Office Action Summary

Application No. 09/460,007	Applicant(s) Harper, Jr.
	Examiner Truc Nguyen	Art Unit 2833

DETAILED ACTION

FIG. 1

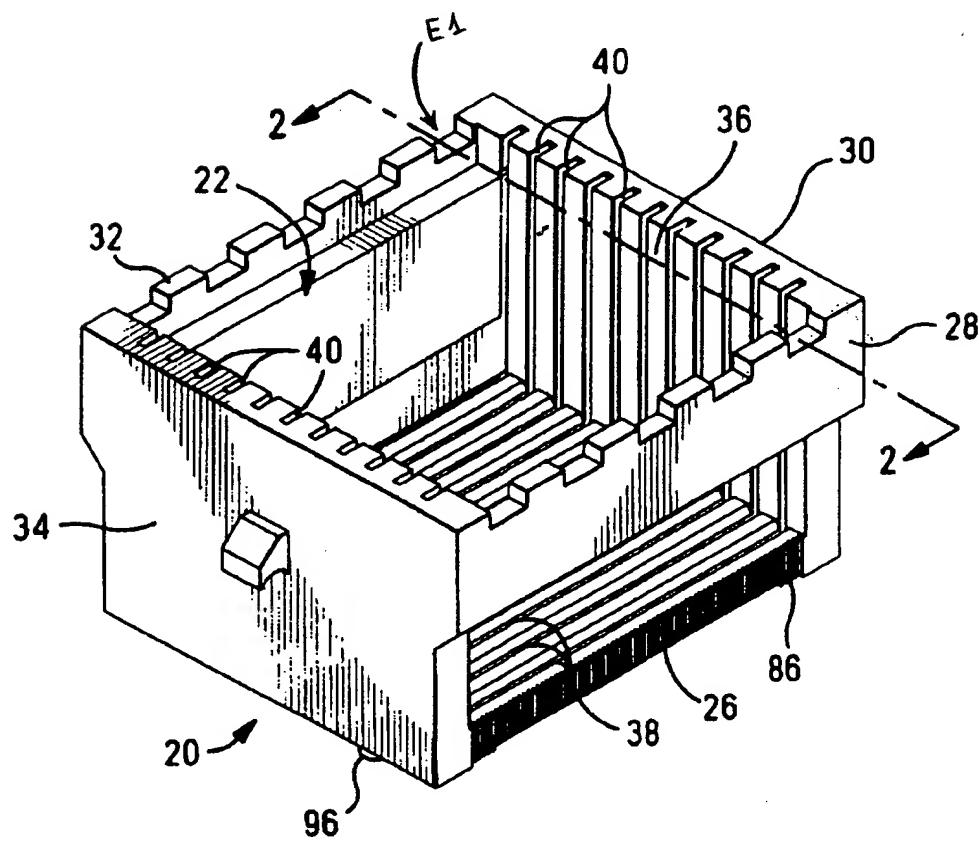
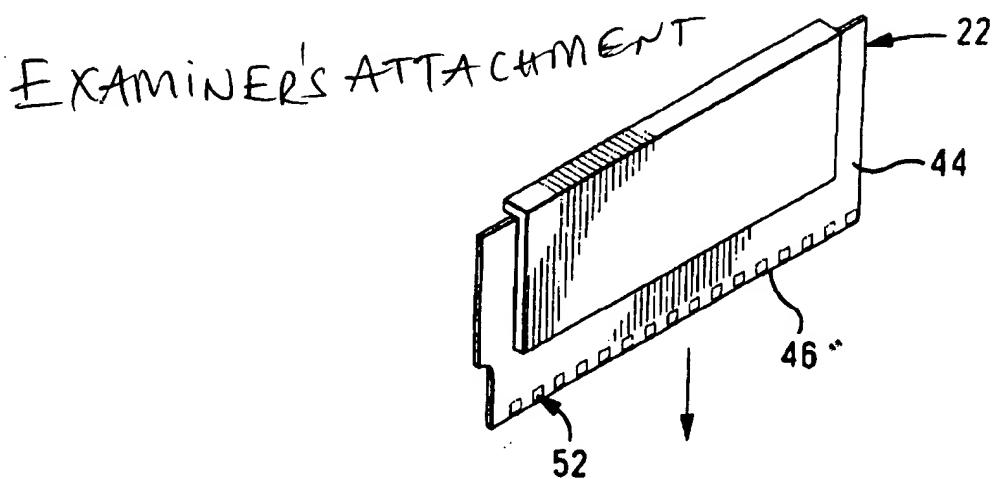
Walker discloses in Figure 1, an electrical connector housing (20) comprising a notch (E1) located only at location furthest from neutral point of the housing, the notch extending through a distal end of the peripheral wall from an inner face to an outer face.

Although Walker does not specifically disclose the slot (E1) is for the purpose of preventing warpage problem of the housing caused by thermal cycling. The structure, disclosed by Walker, would inherently obtain the advantage of the slot being presents in the housing. Thus, it has a capable of preventing warpage of the housing.
